## PJI EXT-HD (Batch 1) Upgrade Document

1. Remove Edge Enhance problem
2. Heat-sink installation to protect HDMI chip
3. MCU software upgrade, remove IR hang and color (green) problem

EXT-HD VGA and BNC version (include DVI output version)

OP Gain vs Frequency with incorrect diode

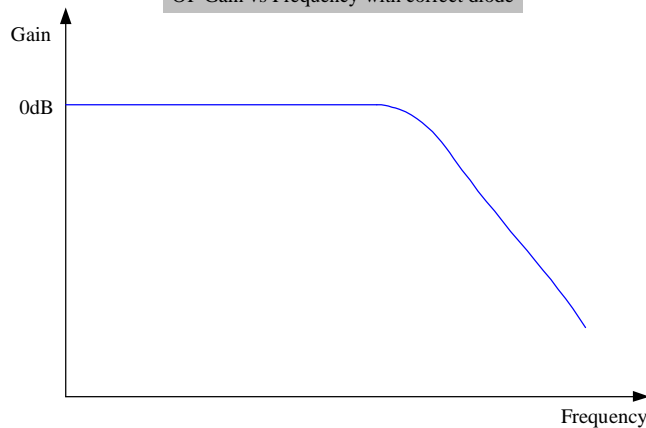
The Video OP on EXT-HD has very high bandwidth and high speed. And there are some diodes used for gamma boost. The diode vendor sent the wrong type of diode to PJI Inc. The Wrong type of diode (have S4 marking) have 15 times larger capacitance than correct diode (marking is S1 or S2 or S3), the capacitance introduce a gain boost at high frequency (about 10MHz~100MHz). So the high frequency component in video signal and anti-aliasing noise from DAC will amply cause ring (edge too sharp), **change to correct diode and add a post filter between DAC and Video OP will solve this problem**

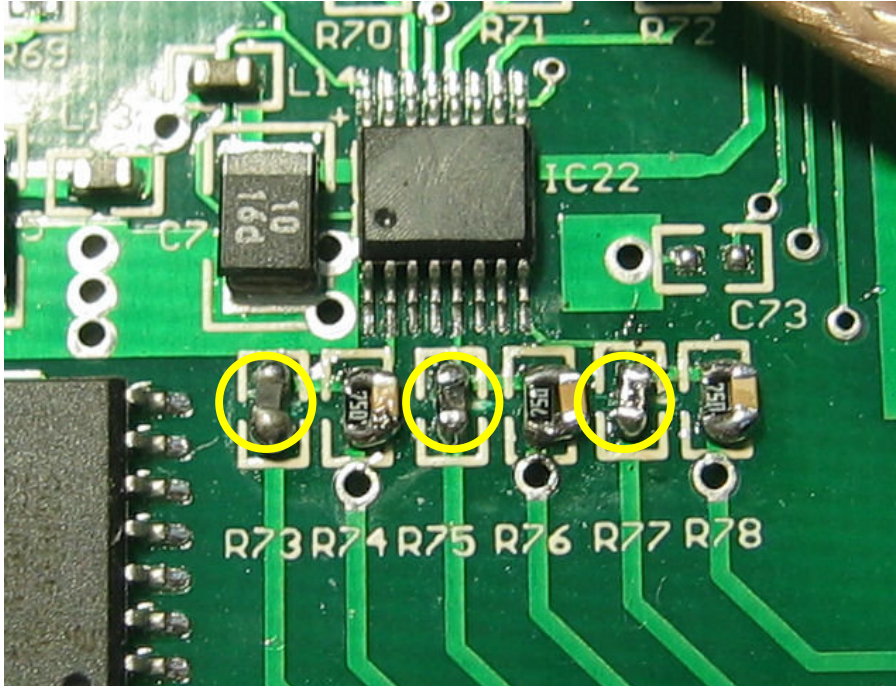
1. cut off the trace on the R73 R75 R77

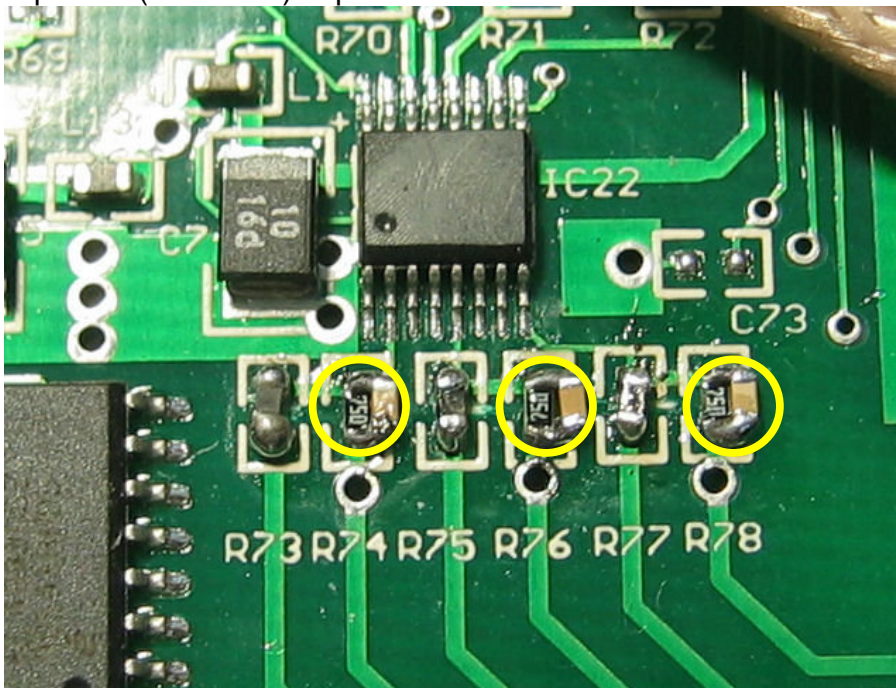
2. Place beads on R73 R75 R77 , bead spec is 220ohm @100MHZ 0603 size

3. Place 22pF capacitor (0603 size) in parallel with R74 R76 R78

### Change diode on EXT-HD BNC version:

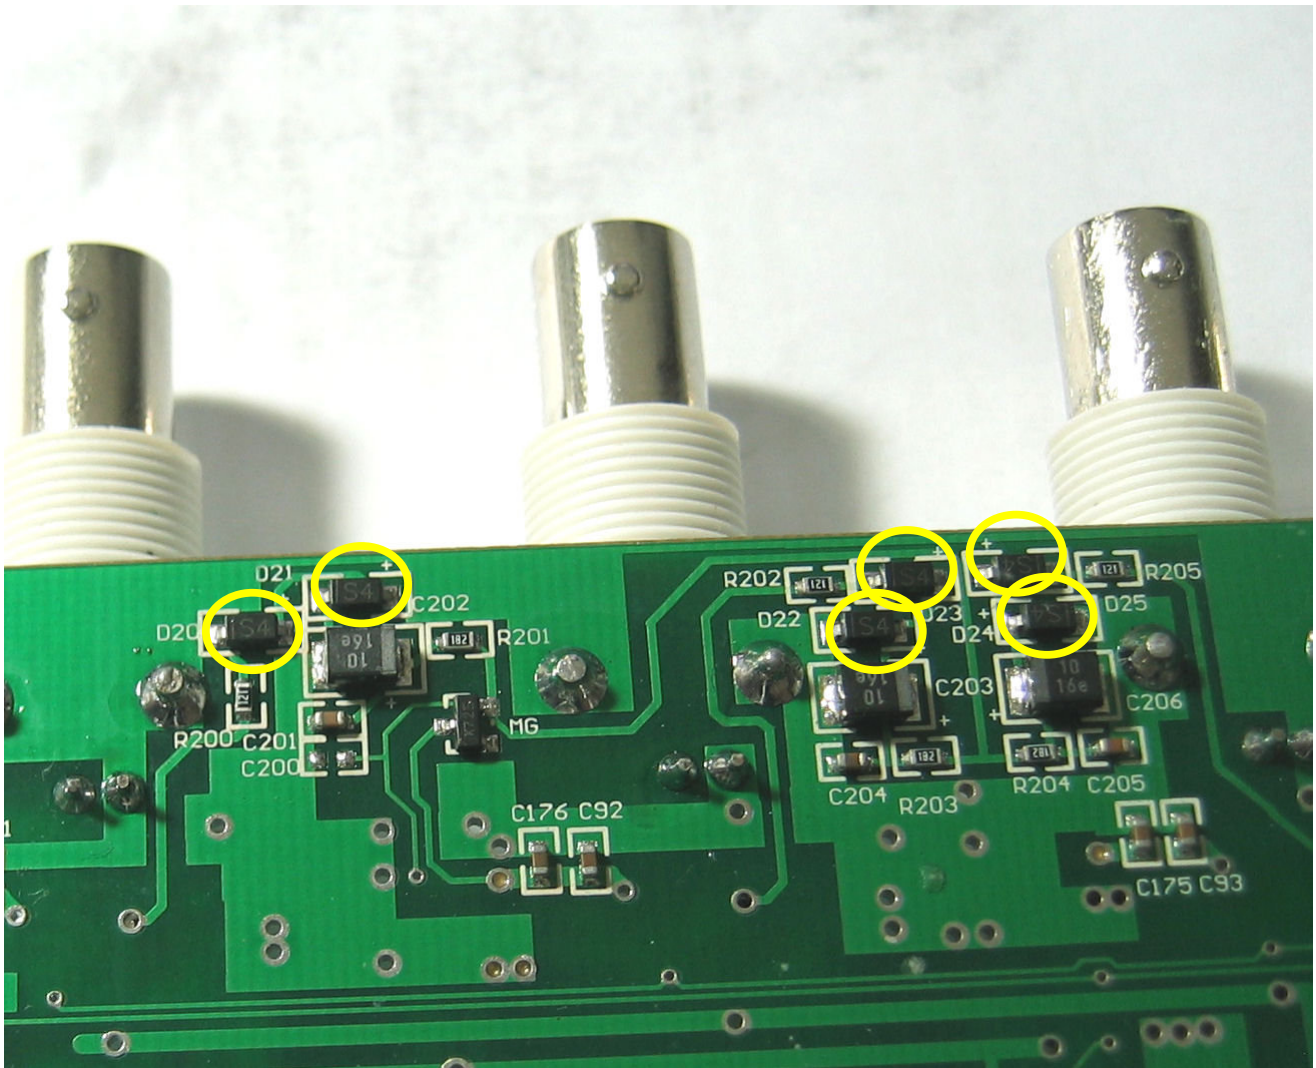
Remove the diodes (marking with S4) D20, D21, D22, D23, D24, D25 off, then solder the correct type of diode back.

### Change diode on EXT-HD VGA version:

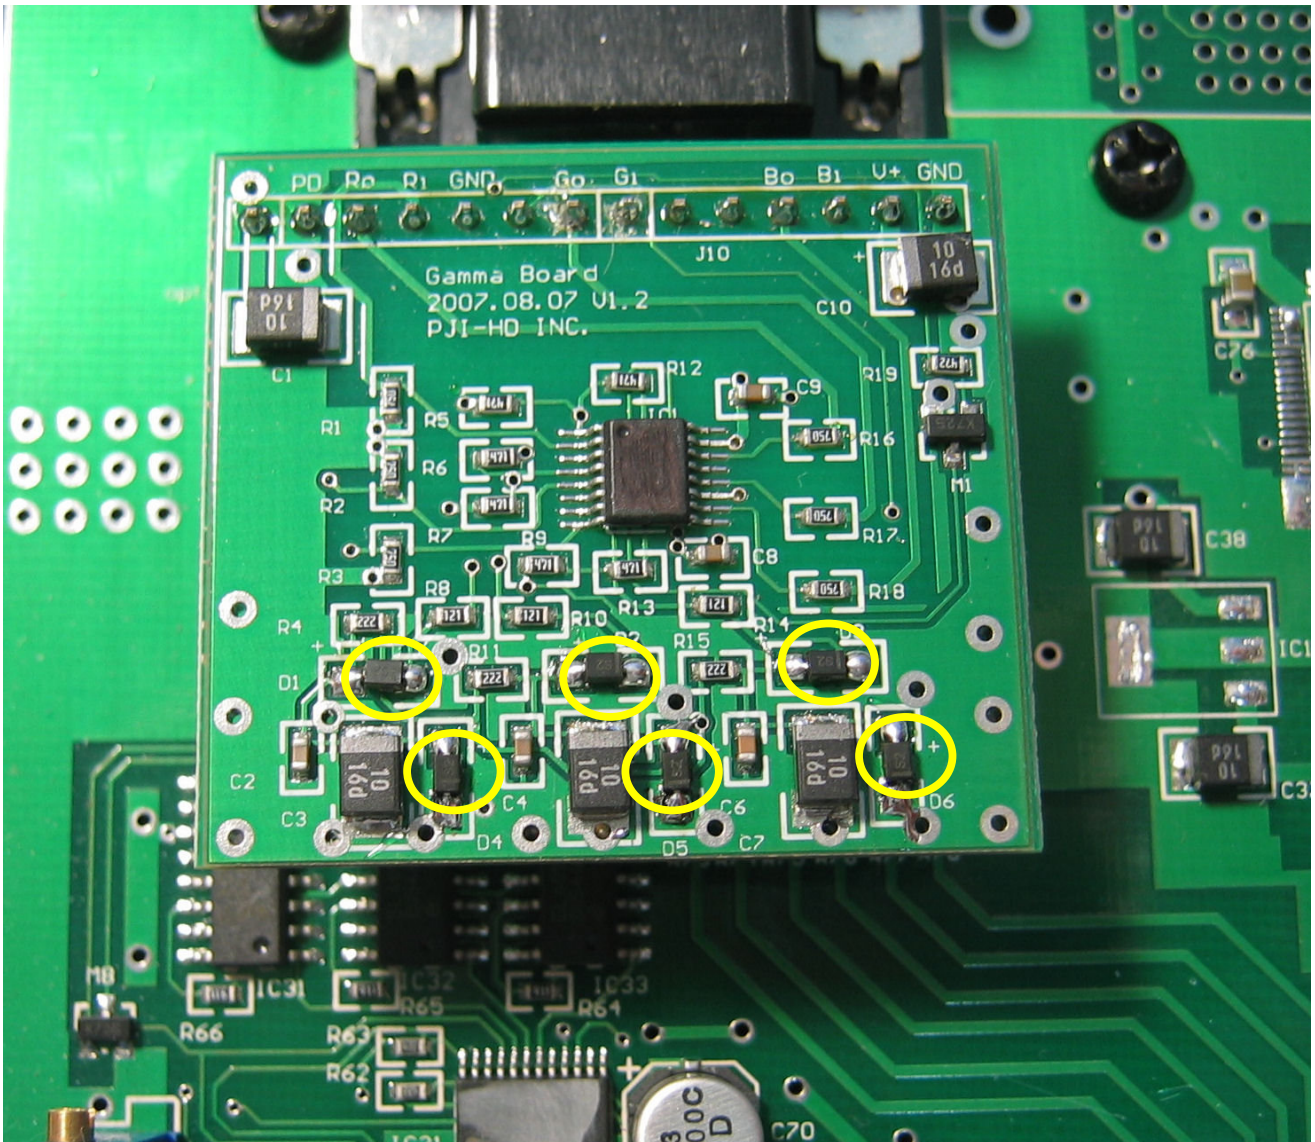
Remove the diodes (marking of S4) D1, D2, D23, D4, D5, D6 off, then solder the correct type of diode back.

## 2. Add the Heat-sink for HDMI chip:

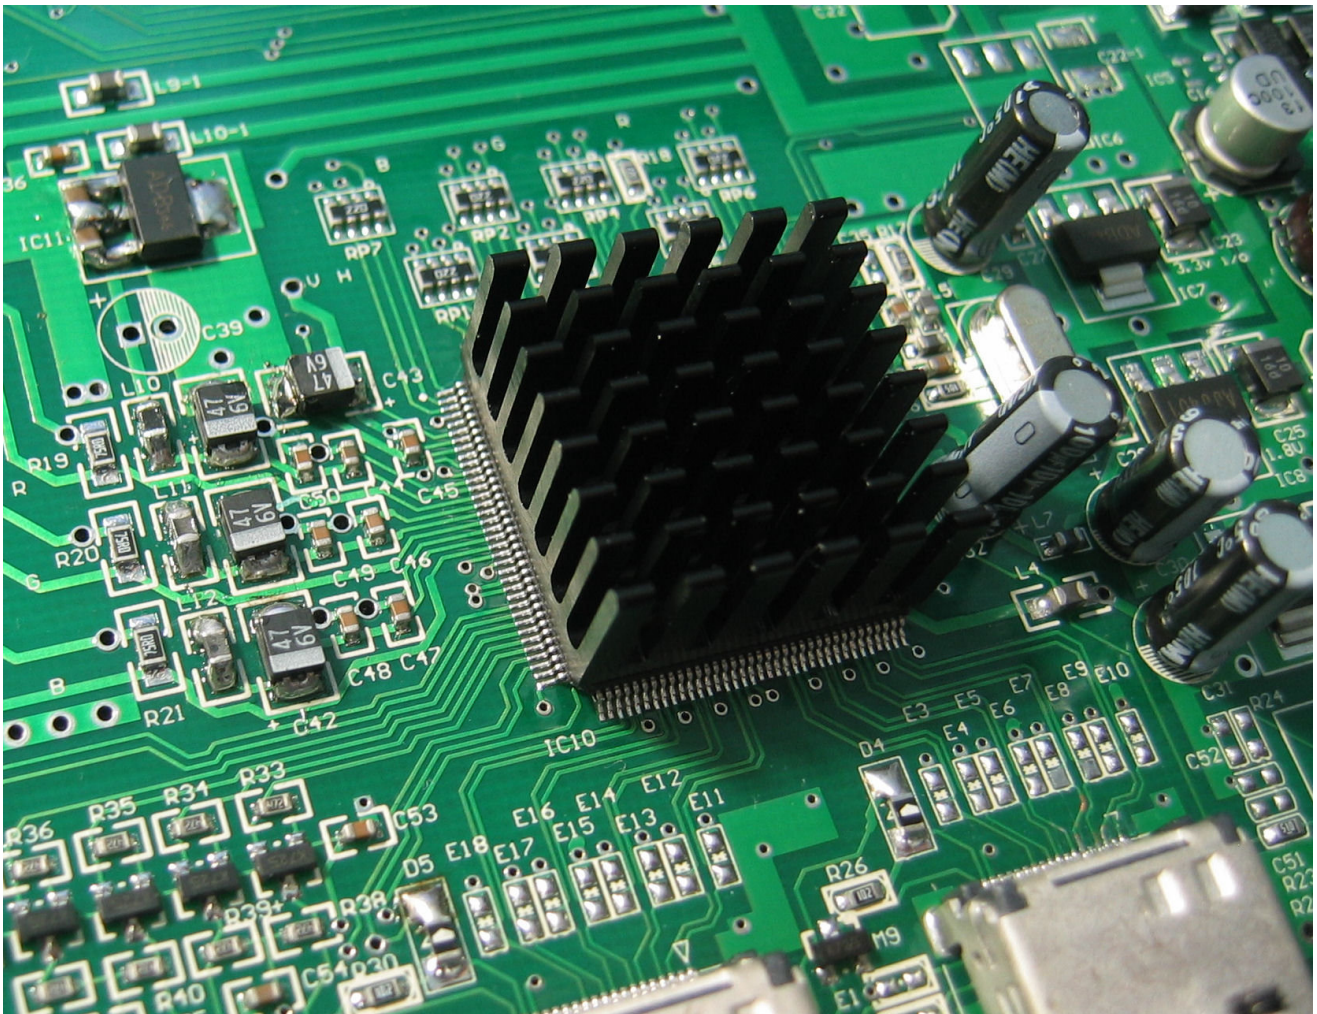
When running 1080p HD signal the chip may be too heat, add a heat-sink can longer the chip life.

1. remove the paper on the heat sink
2. Attaches the heat sink on the HDMI chip

### 3. Upgrade Software for EXT-HD:

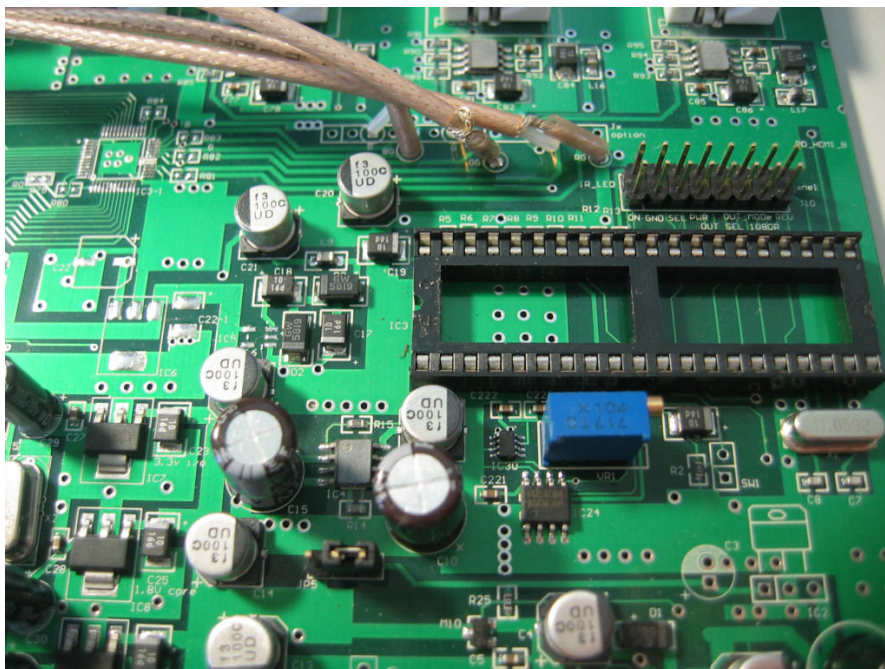
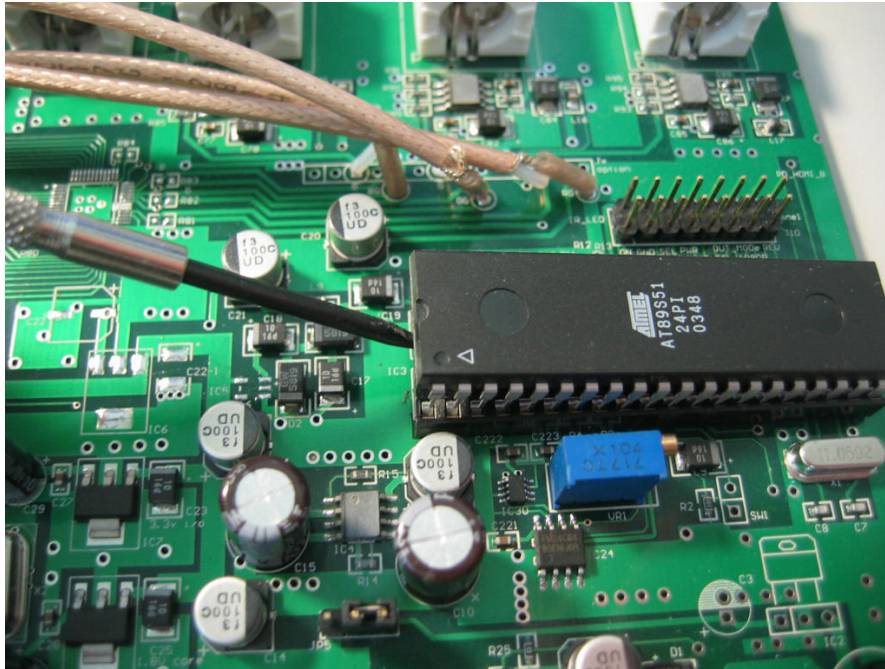
Remove MCU using “-“ shape screw driver, then put the new one back.
